Review of Flood Control Columbia River Basin

Columbia River and Tributaries Study, CRT-63

Final Report

June 1991

Figure 4-9. Libby Project, System Control Requirement, Comparison of Existing and Proposed Rule Curves.

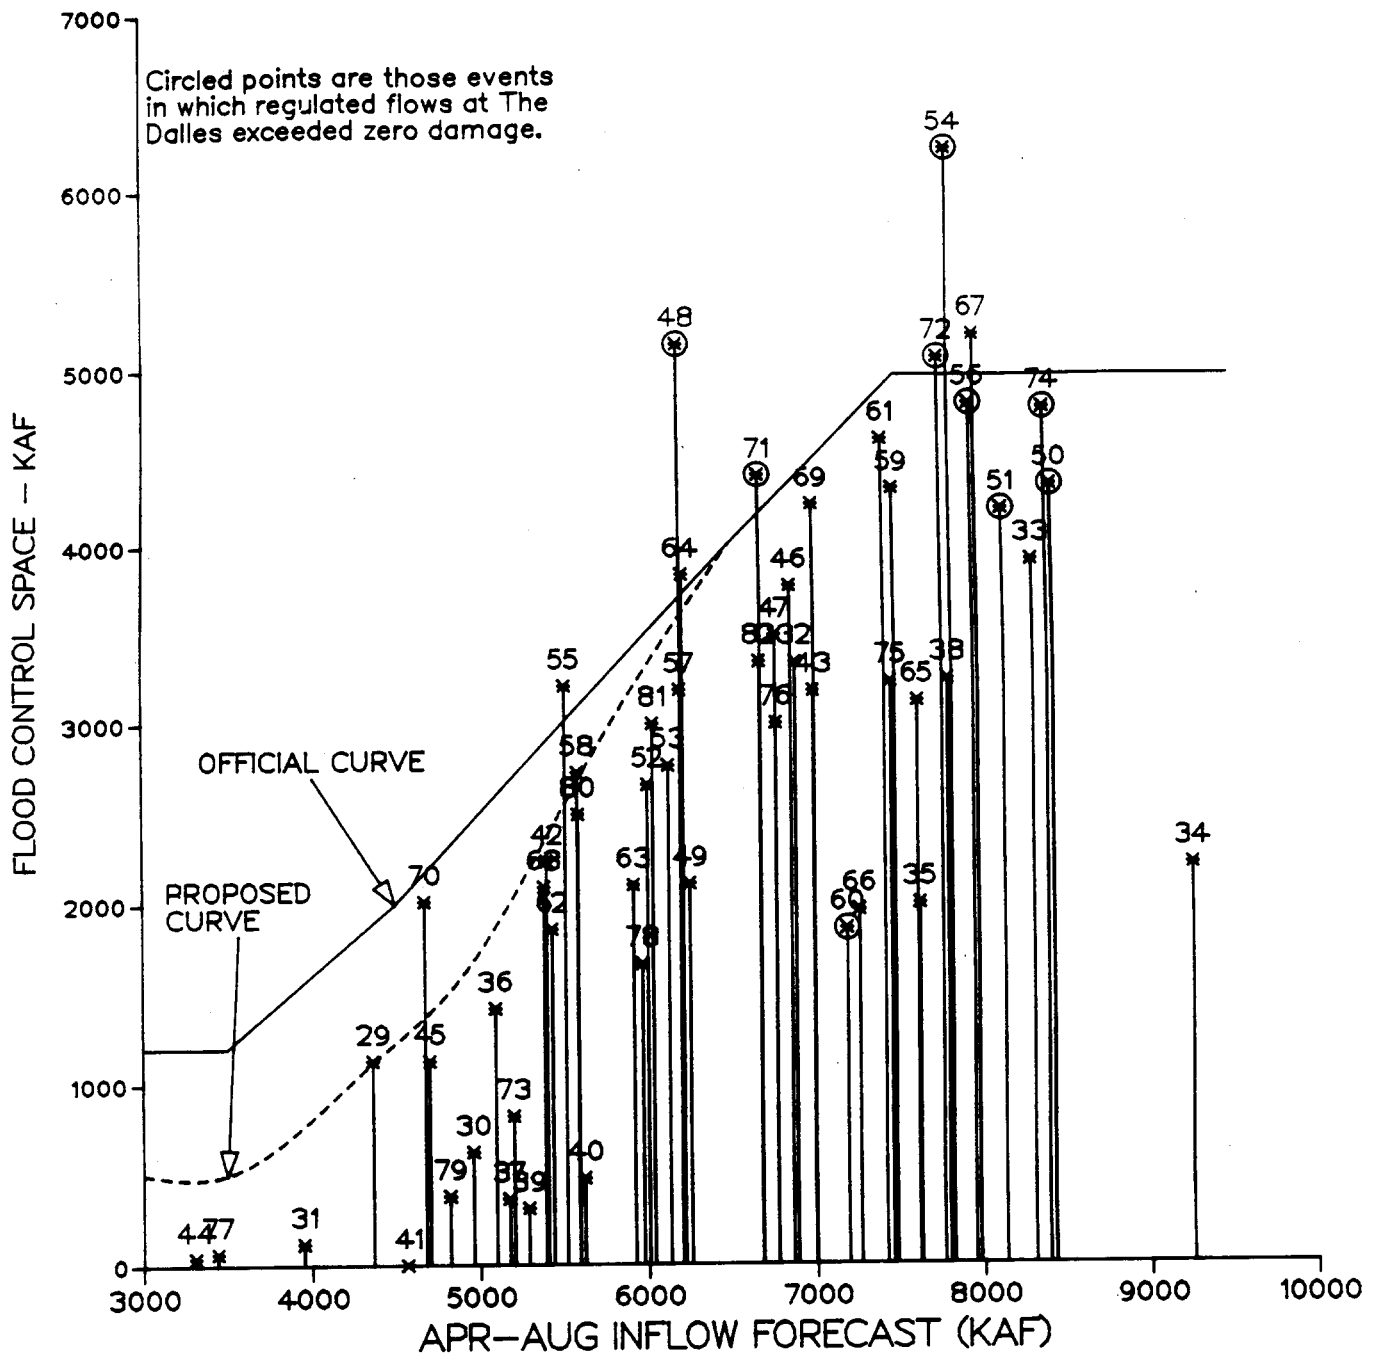
3. In using the envelope curve analysis, was a comparison made of the forecasted volumes versus the observed volumes? For example, in the Libby project (Figure 4-9) the 1948 water year shows a simulated forecast of approximately 6300 kaf whereas the observed volume was about 8454 kaf. If enough of these deviations were to occur, would they bias the results? If this was already investigated, it would be helpful to include an explanation in the Final Report.

4. In Figure 4-9, we believe that the dotted line above the 5800 kaf point should coincide with the solid line. We believe that the dotted line as drawn gives too much weight to the one year, 1948. We think the reservoir space represented by the difference between the two lines would be better used for power purposes.

Paragraph 4 - Proposed increase in flood control storage for Libby in Figure 4-9 (and 4-8).

Figure 4-17. Grand Coulee Project, Comparison of Alternative Rule Curves.

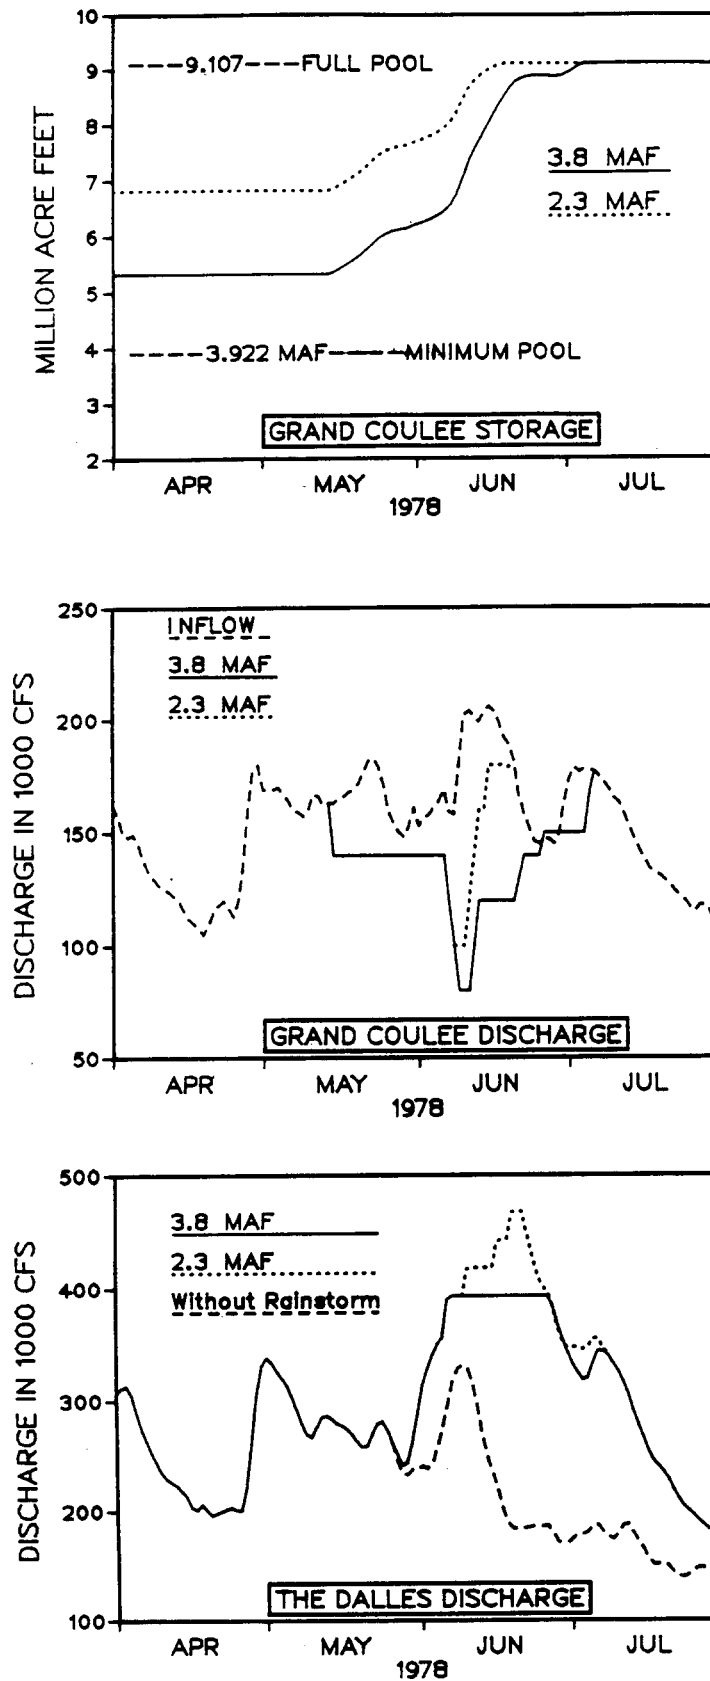
5. Referring to Figure 4-17, will BPA be able to continue to use the maximum rate of drawdown (1.5 feet per day) to meet the proposed drawdown curve?

Paragraph 5 - Rate of drawdown for Grand Coulee, Figure 4-17.

Figure 4-19. Results at The Dalles of System Simulations with Varying Flood Control Space at Grand Coulee.

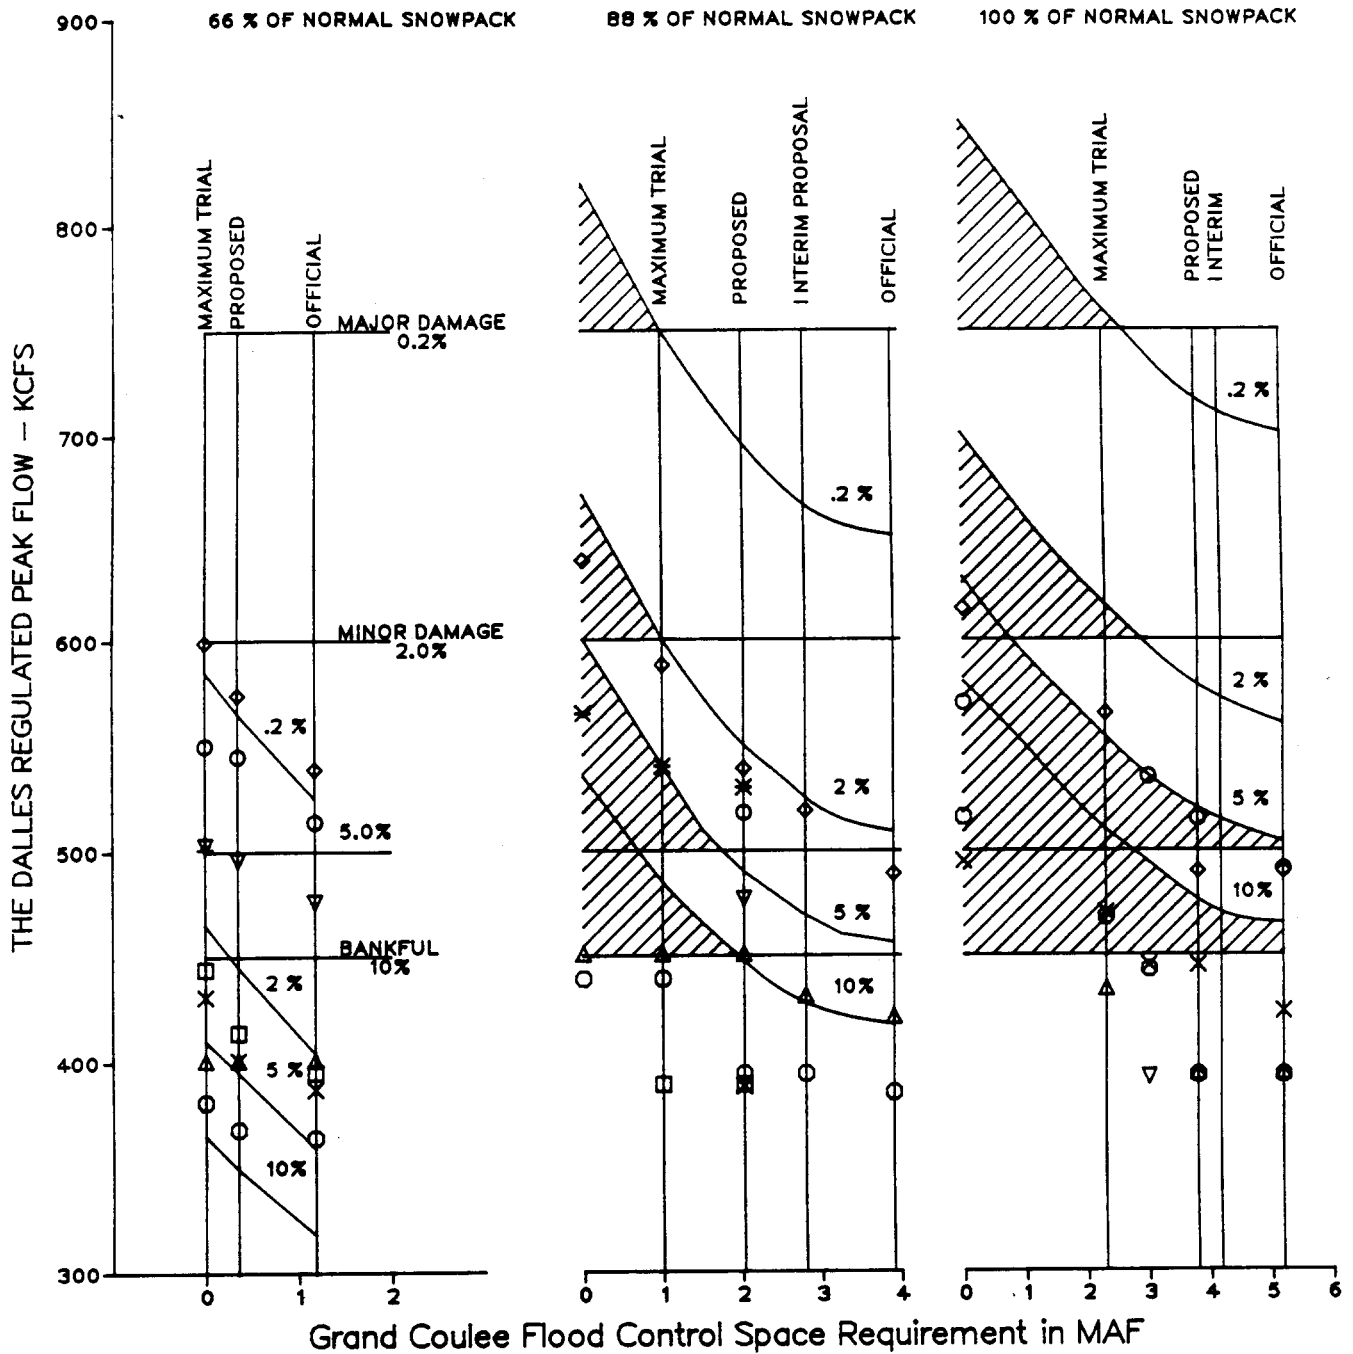
10. Figure 4-19 on page 63 would benefit from clarification. It is difficult to interpret.

Figure 4-21. Dworshak Project, Existing Flood Control Diagram.

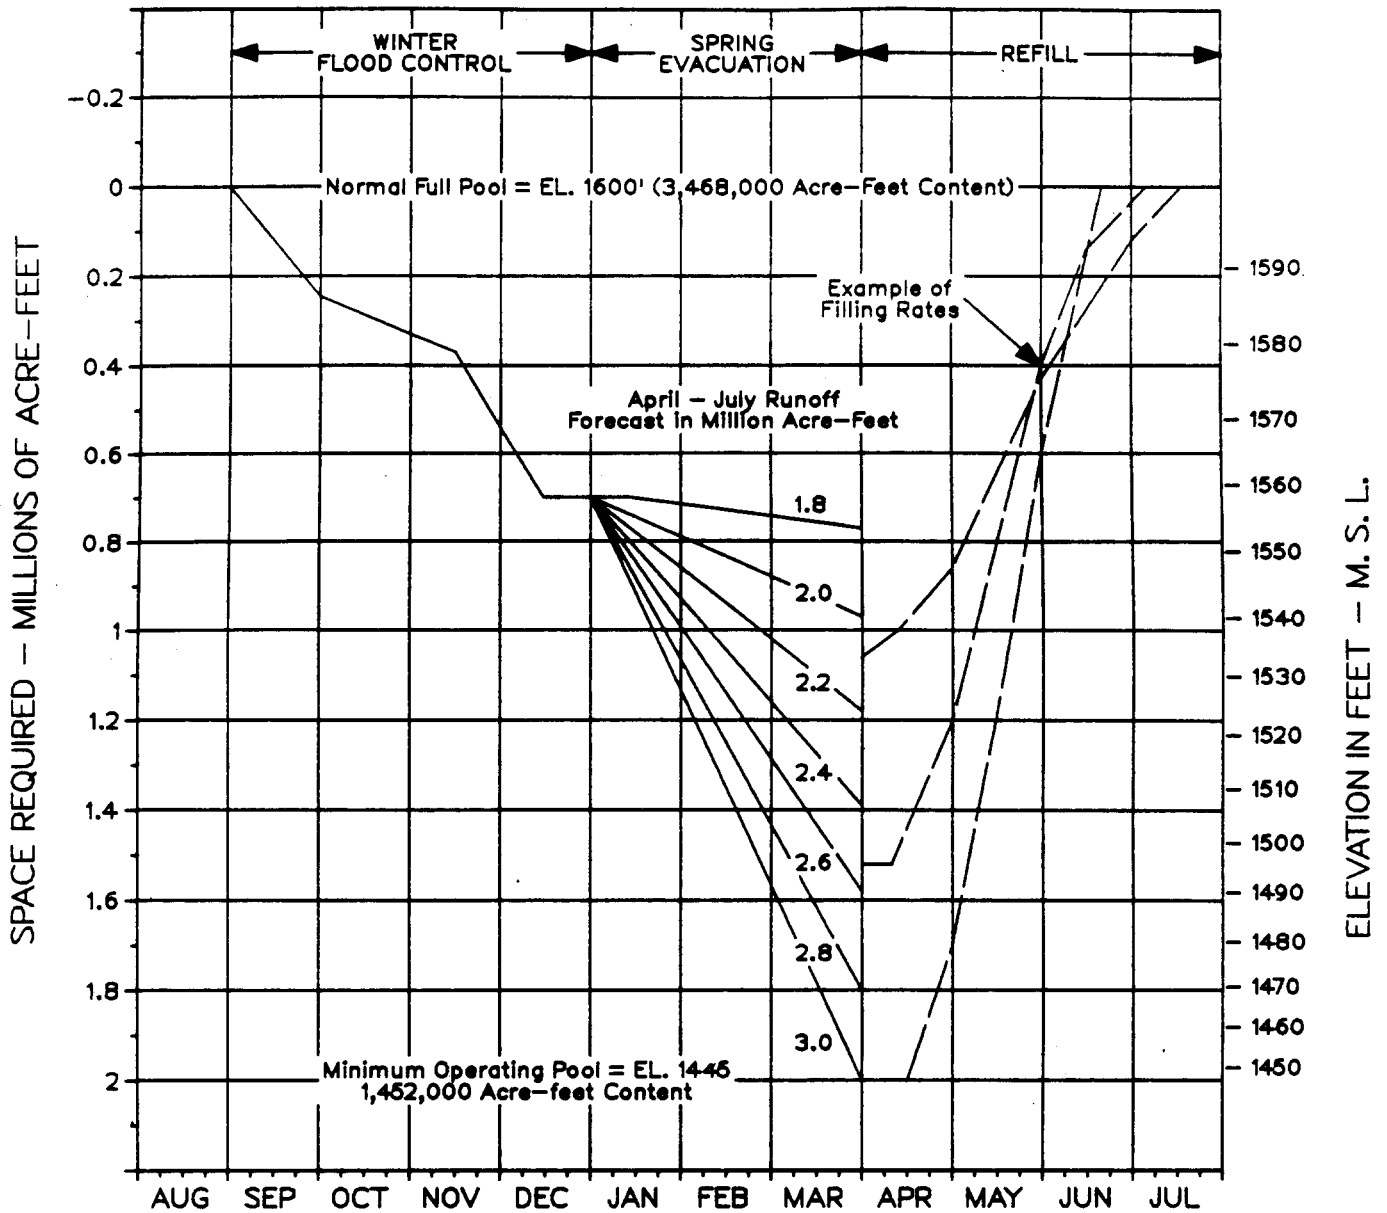
6. Referring to Figure 4-21, variable refill curves are not always used in actual practice to govern the operation of Dworshak during the refill period, and the inclusion of Notes 2b and 4 on Figure 4-21 is therefore misleading. We would prefer that the practice indicated in these Notes actually be followed, or that some other appropriate firm constraint be developed and followed, so that BPA would have a consistent basis on which to plan and operate.

Paragraph 6 - Comments on figure 4-21, Dworshak operation.

Figure 4-32. Dworshak Project, Simulated vs Observed Regulation of 1987 Runoff.

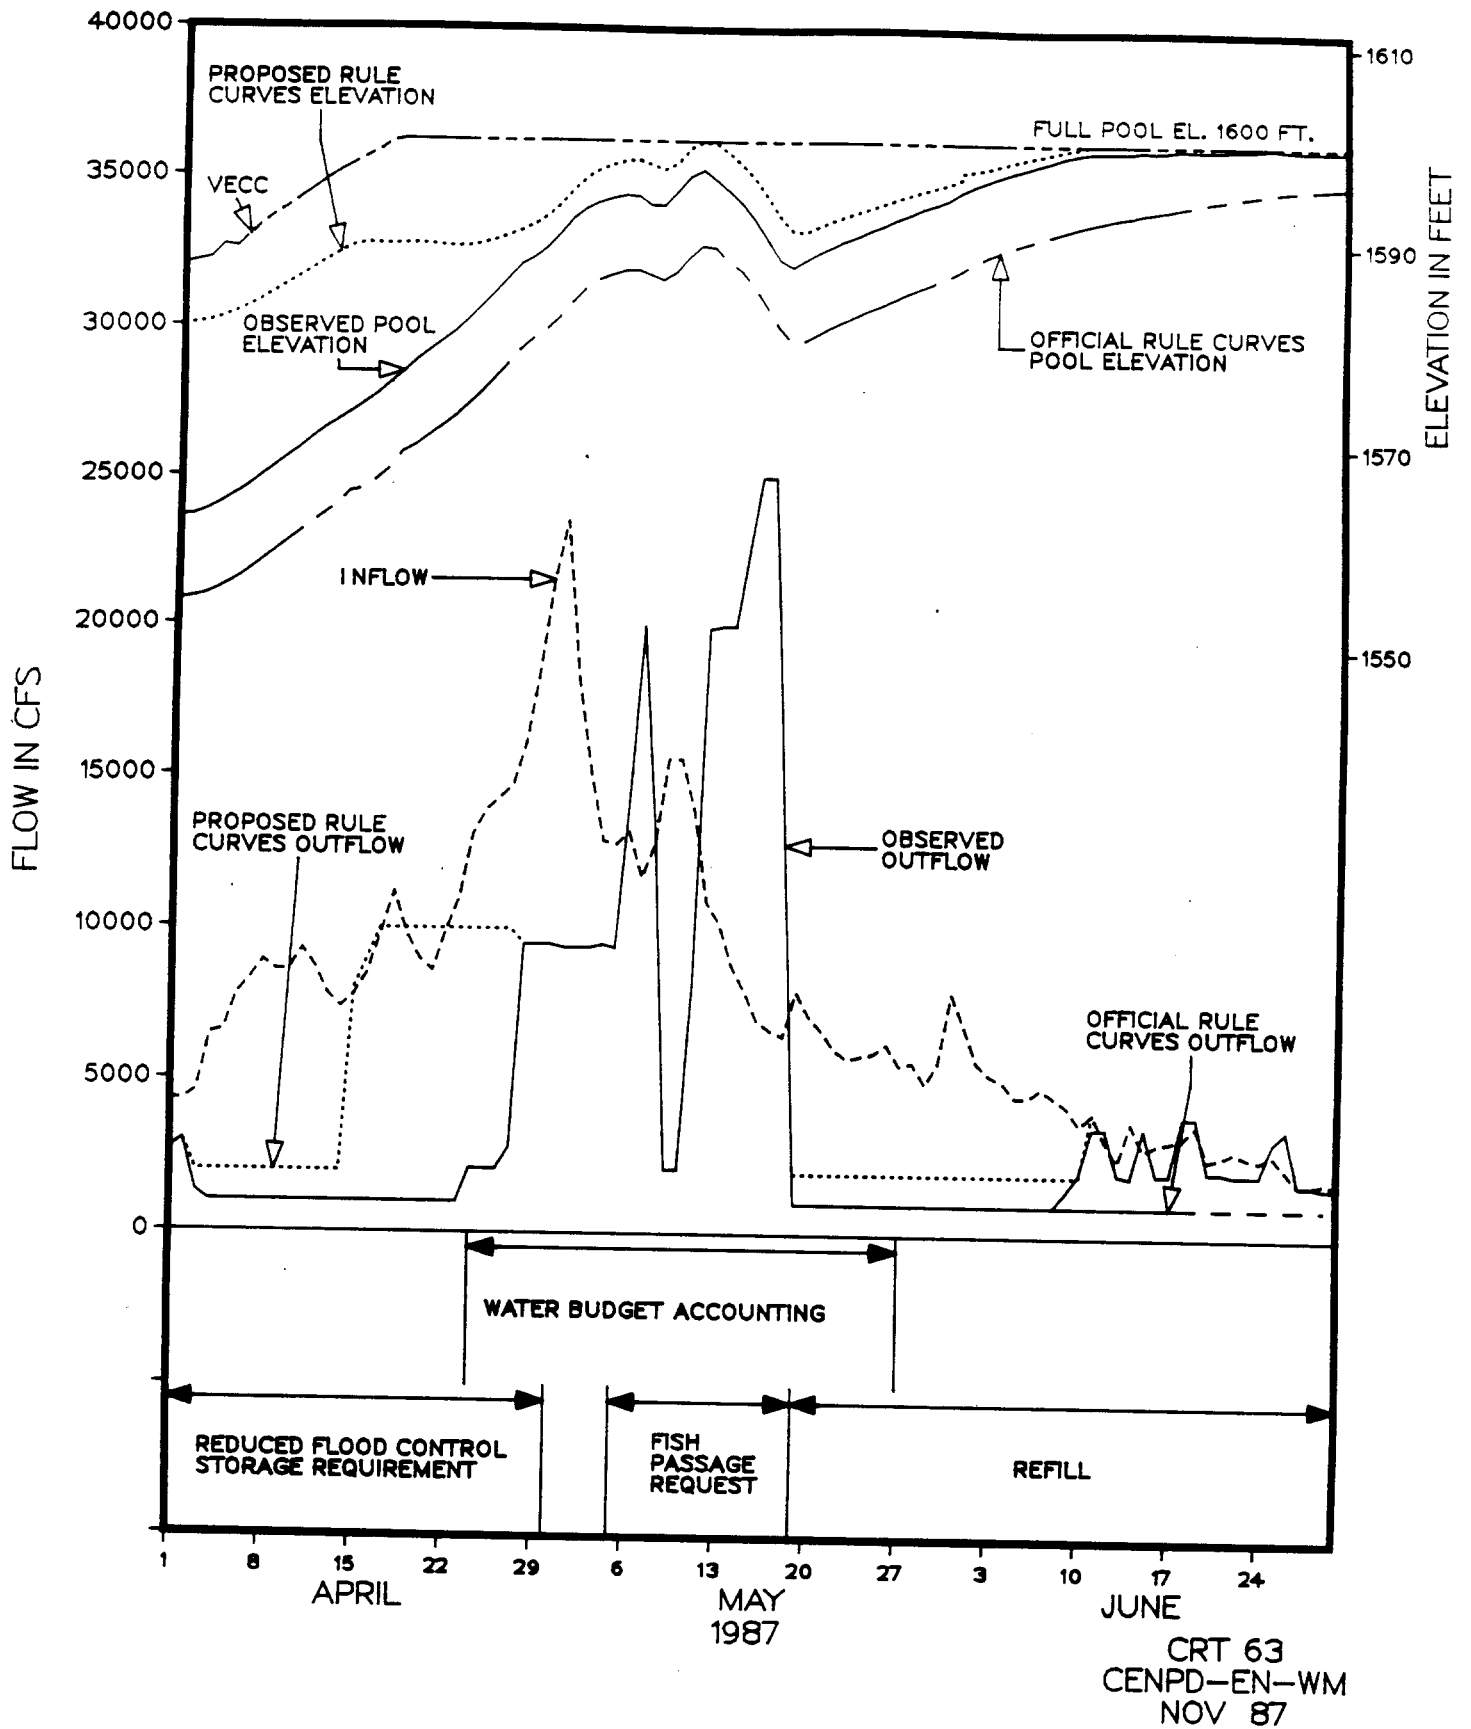
14. In Fig. 4-33, are the Dworshak project rule curves labeled correctly? Can this figure be simplified?

14. Comment noted. Revisions in the plot (now figure 4-32) and text have been made.
